Proposal for Supplement 5 to the 02 series of amendments to UN Regulation No. 129

Submitted by the expert from Spain

Annex 2., amend to read:

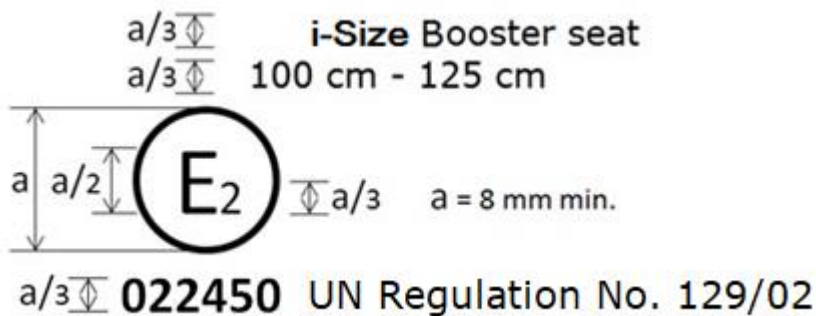
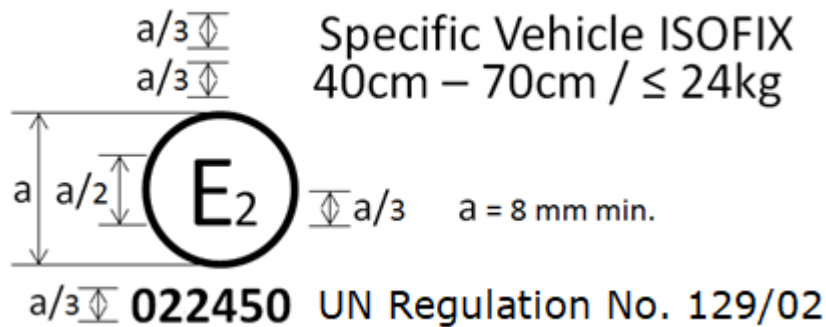
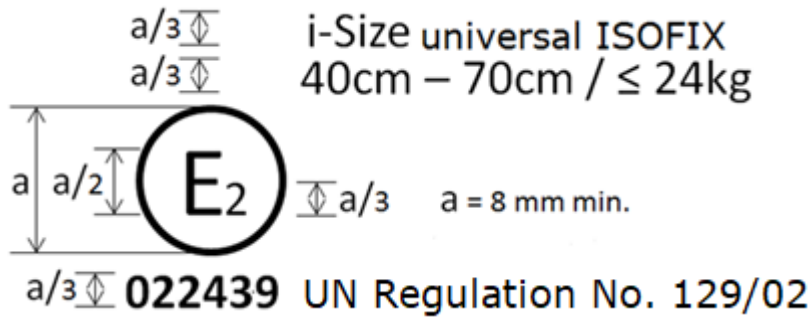
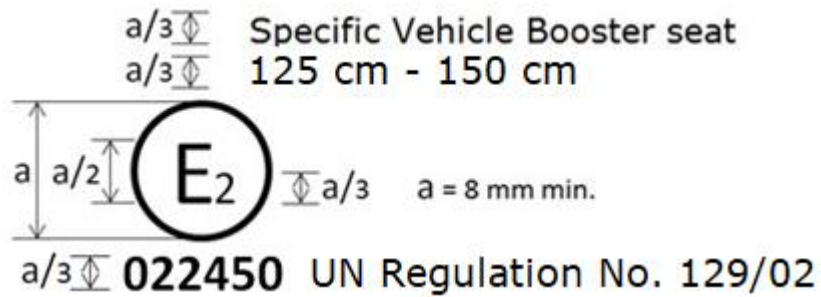
The Enhanced Child Restraint System bearing the above approval mark...

125 cm - 150 cm size range

1. Dimension of the approval number is currently not specified
2. Correct wording for regulation used. UN Regulation No. 129/02 instead of Regulation No. 129/02
3. Changed the 145 cm stature of the Specific Vehicle Booster seat to 150 cm stature as this is the upper limit.
